Access Compliance Report

Public Rights-of-Way

(Curb Ramps)

Intersection ID: 7724	Main Street: BEATTIES_FORD_RD	Cross Street: N_I-85_EXIT_37_RA	Location: SW
ADA ID: 59685713EC4D	Ramp Type: PerpDiag	Initial Pass/Fail: Fail	Overall Compliance: No
Severity Score: 12.5			
Codes/Mitigation Info/Possible Solution		Field Measurements/Component Compliance

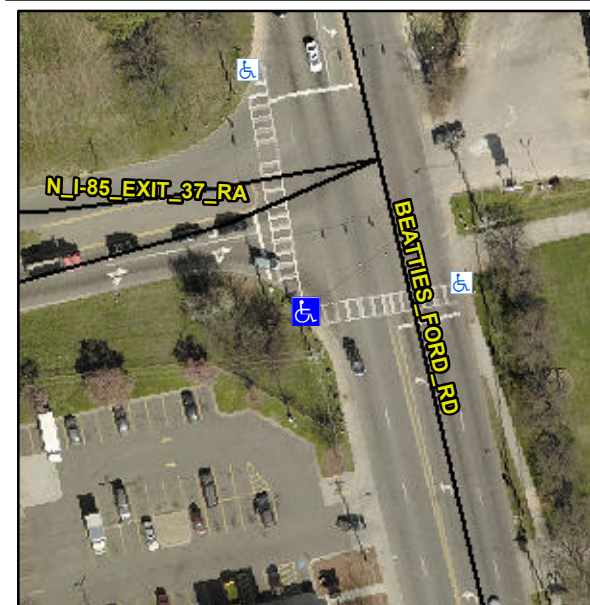
Not Found, R304.2.2

Compliance	Description	Data	Compliance	Description	Data
N/A	Ramp Length (in)	62.0	No	Ramp Slope (%)	11.8
Yes	Ramp Width (in)	48.0	Yes	Ramp XSlope (%)	0.3
N/A	Flare Type LT	N/A	N/A	Flare Type RT	N/A
N/A	Flare Slope LT (%)	N/A	N/A	Flare Slope RT (%)	N/A
N/A	Flare Traversable LT?	N/A	N/A	Flare Traversable RT?	N/A
N/A	Landing Length (in)	N/A	N/A	DWS Provided?	N/A
N/A	Landing Width (in)	N/A	N/A	DWS Contrast?	N/A
N/A	Landing Slope (%)	N/A	N/A	DWS Length (in)	N/A
N/A	Landing X Slope (%)	N/A	N/A	DWS Full Width?	N/A
N/A	Landing Curb? (Y/N)	N/A	N/A	DWS Offset (in)	N/A
N/A	Shared Landing?	N/A			
N/A	Gutter Ponding?	N/A	N/A	Gutter Slope (%)	N/A
N/A	Gutter Lip Ht (in)	N/A	N/A	Gutter X Slope (%)	N/A
N/A	Painted X Walk1?	Yes	N/A	Painted X Walk2?	No
	X Walk 1 Direction	To N		X Walk 2 Direction	To E
N/A	X Walk 1 Width (in)	109.0	N/A	X Walk 2 Width (in)	N/A
	X Walk 1 Slope (%)	0.9		X Walk 2 Slope (%)	0.3
	X Walk 1 X Slope (%)	0.6		X Walk 2 X Slope (%)	3.7

Remove & Replace Curb Ramp With Two New Directional Ramps or Equivalent.
